**MONTGOMERY COUNTY HISTORIC PRESERVATION COMMISSION**  
**STAFF REPORT**

<b>Address:</b>	10905 Montrose Avenue, Garrett Park	<b>Meeting Date:</b>	1/5/2022
<b>Resource:</b>	Contributing Resource <b>(Garrett Park Historic District)</b>	<b>Report Date:</b>	12/29/2021
<b>Applicant:</b>	Christopher Walen & Yasmine Belkaid Tamar King, Architect	<b>Public Notice:</b>	12/22/2021
<b>Review:</b>	HAWP	<b>Tax Credit:</b>	N/A
<b>Permit Number:</b>	978323	<b>Staff:</b>	Dan Bruechert
<b>PROPOSAL:</b>	Partial Demolition and Construction of Rear Addition, Rear Deck Construction, Front Porch Alteration

# APPLICATION FOR HISTORIC AREA WORK PERMIT

**PROPOSED RENOVATION FOR:**

Figure 3: 1950 Sanborn Map showing the outline of the historic construction.

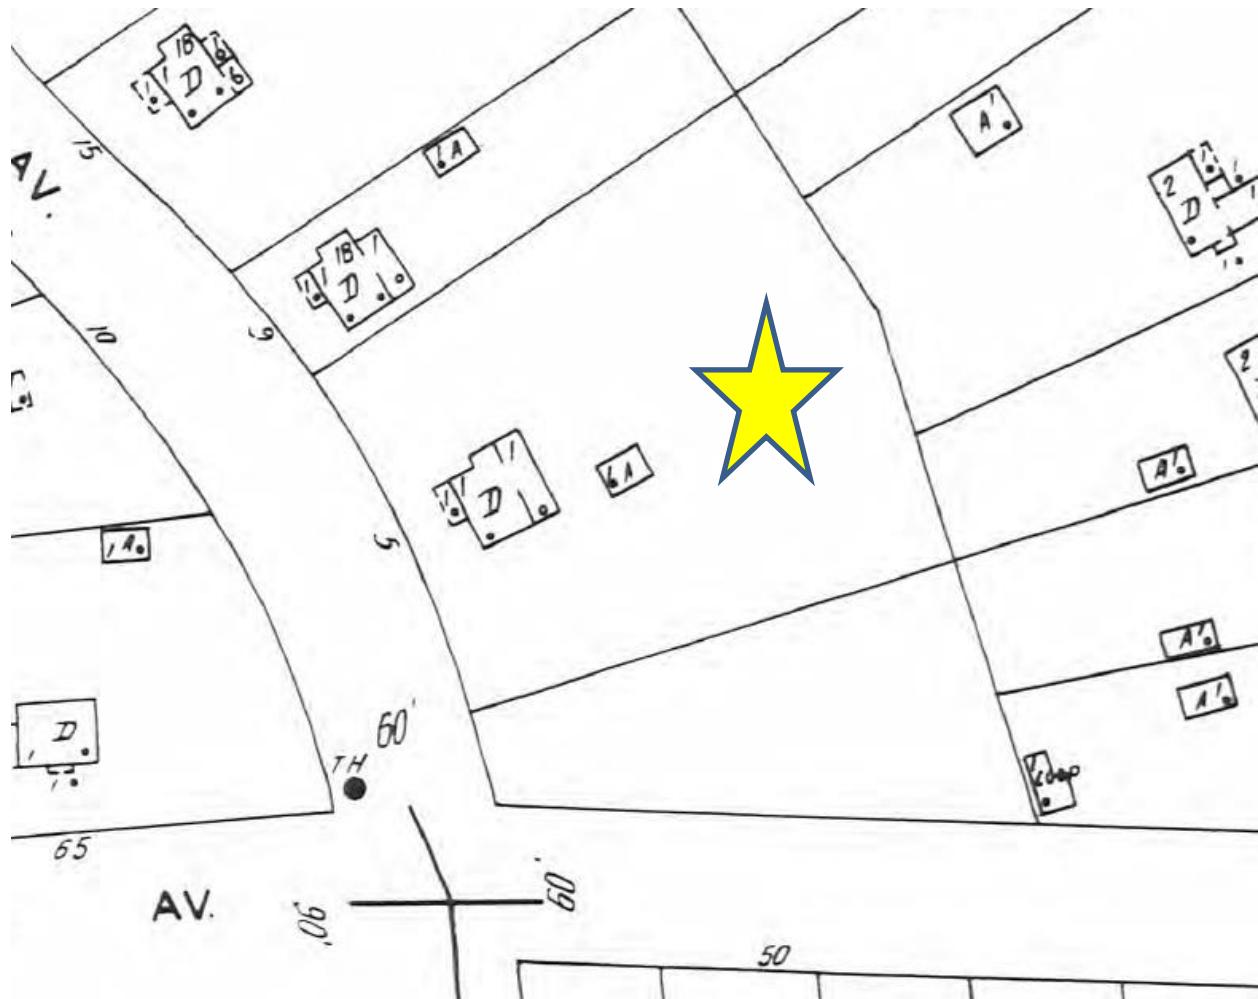
At the rear of the house, there is a small one-story section that appears to be an enclosed rear porch that is used currently as the kitchen. The rear has a combination of siding and window configurations and does not contribute to the historic character of the house. The applicant proposes to demolish this section of the house and construct a rear addition.

### Proposed Exterior Elevations

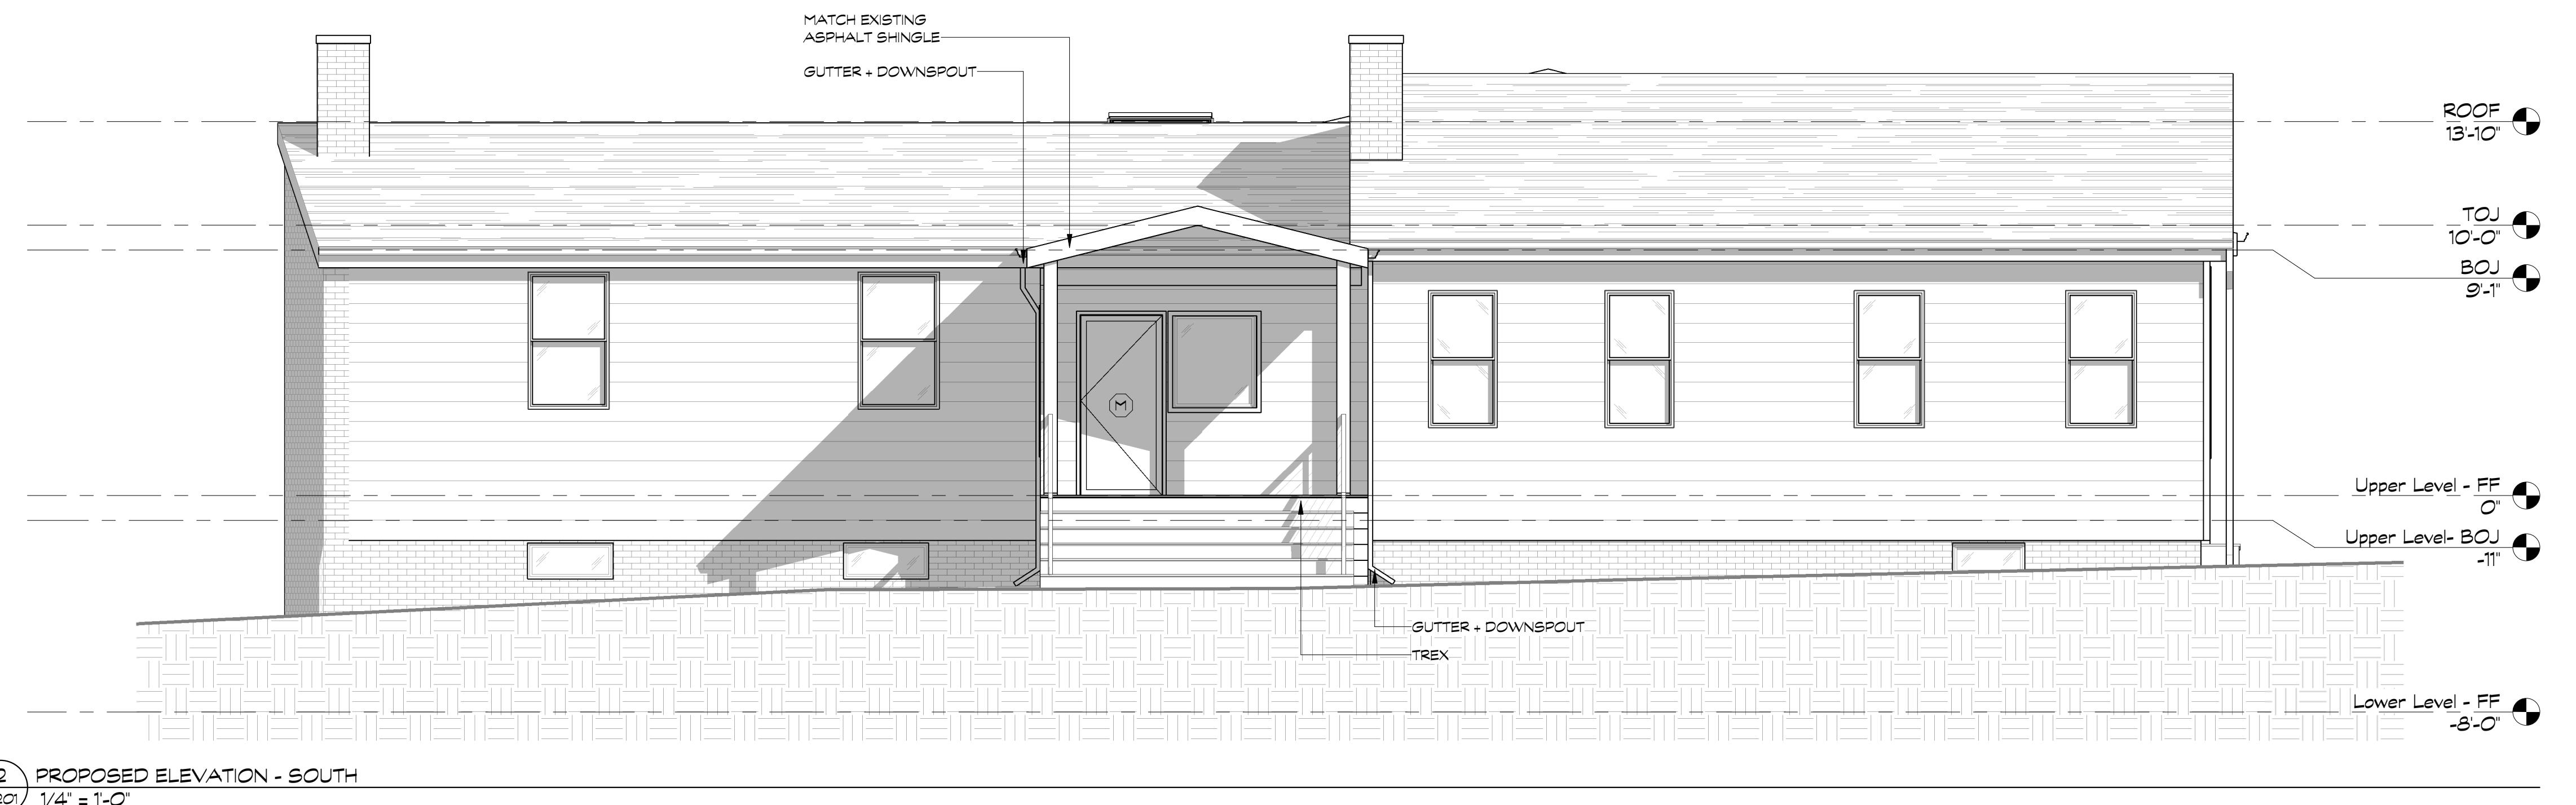
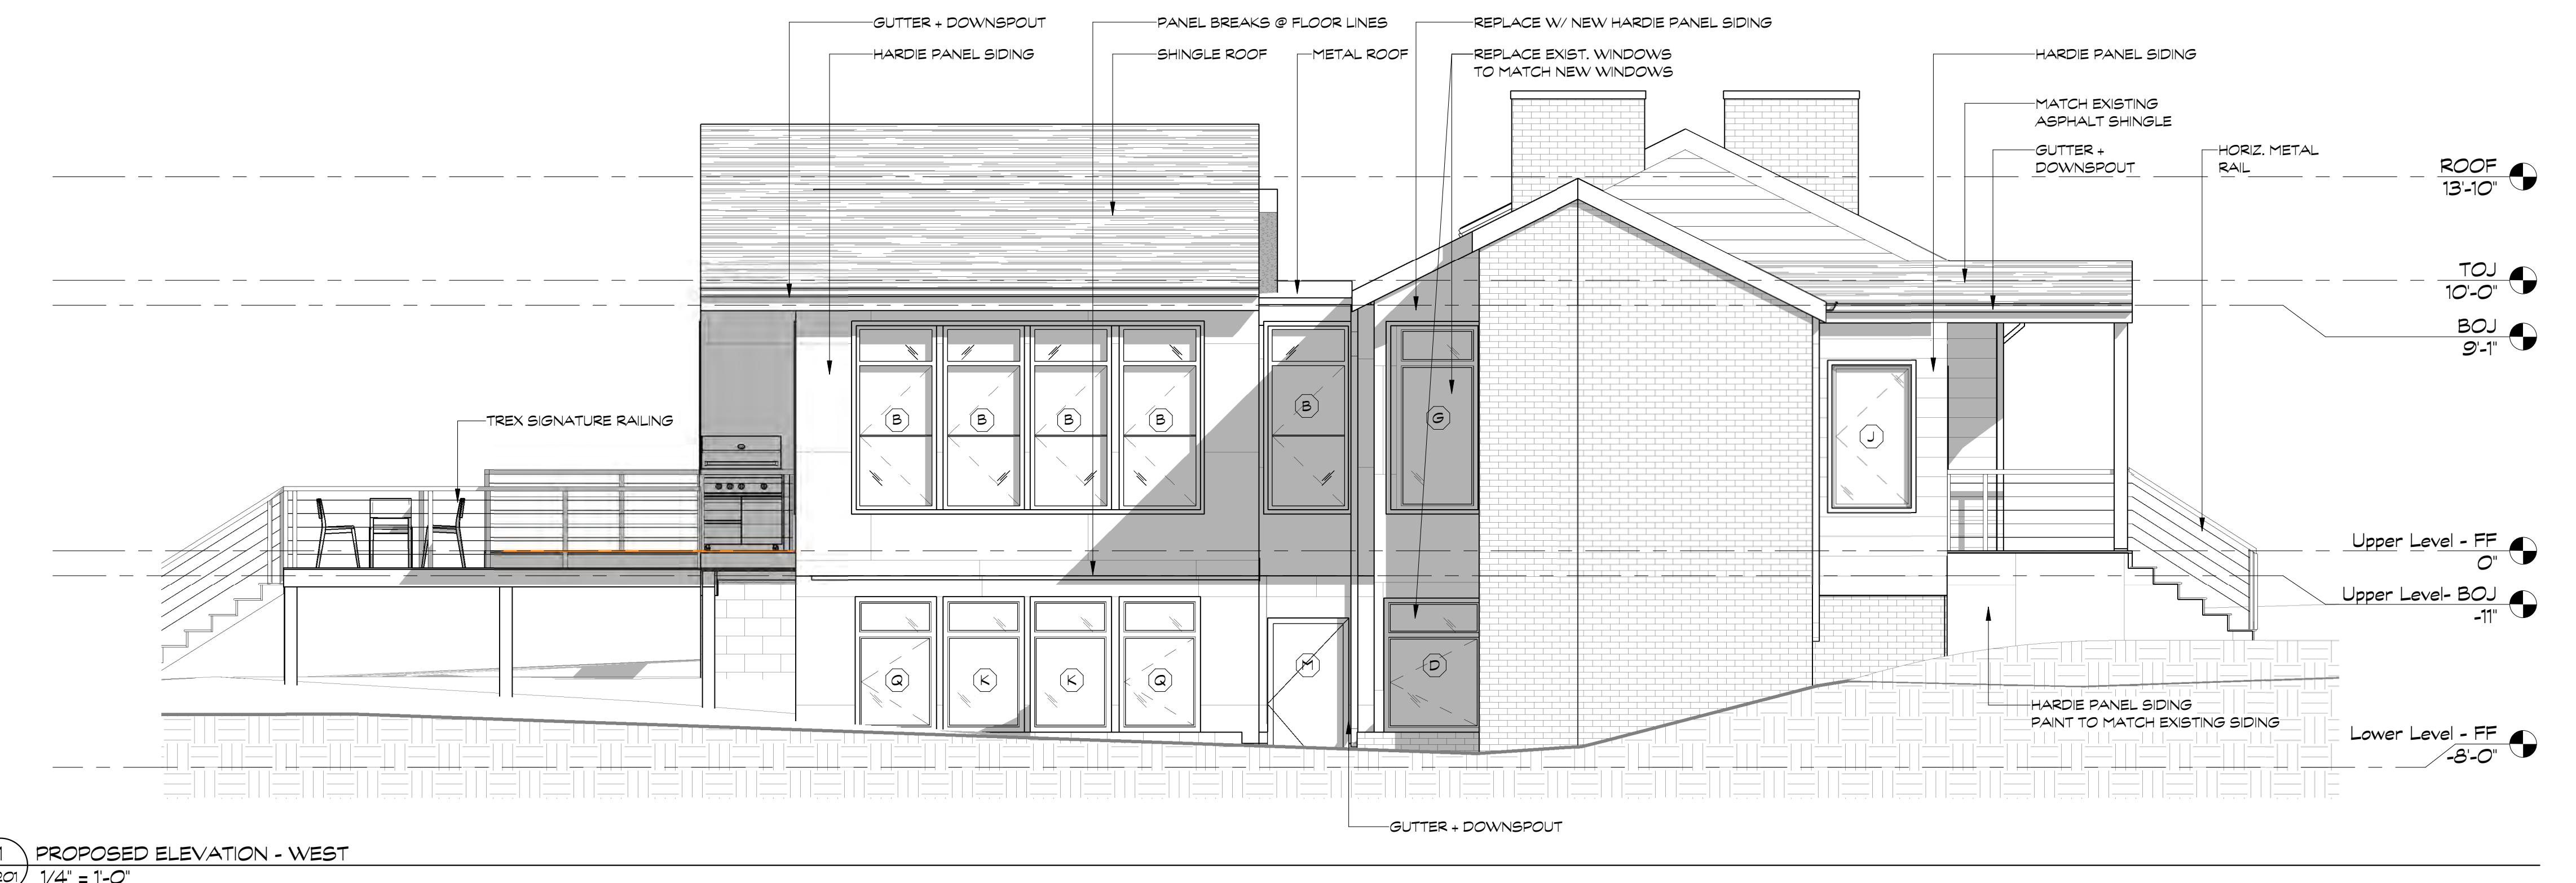
The historic front porch aligned with the left side of the historic construction (see Fig. 2 below). After the addition was constructed, sometime after 1963, a side-loading front porch was constructed to access the new entrance in the building addition. The applicant proposes to reconfigure the entrance with a front-facing gable roof and a new front-loading front porch. The front porch will be covered in a simple wood gable, covered in shingles to match the existing roof supported by square wood columns. The applicant proposes to use Trex for the porch decking and stairs. The railing will be a metal cable railing.

Staff finds the existing front porch is not a historic feature on the house and its loss will not impact the historic character of the house. Many of the Chevy Houses in Garrett Park have a decorative front pediment (see: <https://www.garretparkmd.gov/home/showdocument?id=1038>). Staff finds that the proposed porch is evocative of those earlier features without attempting to replicate the design. Staff finds the design and materials for the proposed pediment are appropriate with the house and surrounding district. Staff finds that the front railing is a clearly contemporary feature that matches the railing on the rear deck, discussed below, and will not be misinterpreted as a historic building element. However, Staff does not find the material and design of the front railing to be compatible with the surrounding district

which, aside from the non-contributing house across the street, has only wood railings. Staff recommends the HPC include a condition for approval that the front porch railing is wood, in a traditional design, and delegate final approval authority to Staff. Finally, Staff finds the proposed Trex composite porch decking and stairs is not compatible with the natural materials (i.e. stone, wood, etc.) found throughout the district. As a composite material, Trex has a more reflective surface than wood and does not develop a patina over time. The HPC has consistently required wood on front porches in the Garrett Park Historic District and Staff recommends they do so in this instance. Staff recommends that the HPC include a condition that the front porch decking and stairs need to be wood. Staff can verify that the condition has been met when plans are submitted for final stamping after the approval.

1. The proposed front porch metal cable railing is incompatible with the house and surrounding historic district. The front porch railing needs to be a traditionally-designed wood railing. Final approval authority to verify that this condition has been met is delegated to Staff.
2. Composite decking, including Trex, is incompatible on the front porch of the house and surrounding district. The front porch deck and stairs need to be painted wood. Final approval authority to verify that this condition has been met is delegated to Staff

1. The proposed front porch metal cable railing is incompatible with the house and surrounding historic district. The front porch railing needs to be a traditionally-designed wood railing. Final approval authority to verify that this condition has been met is delegated to Staff.
2. Composite decking, including Trex, is incompatible on the front porch of the house and surrounding district. The front porch deck and stairs need to be painted wood. Final approval authority to verify that this condition has been met is delegated to Staff;
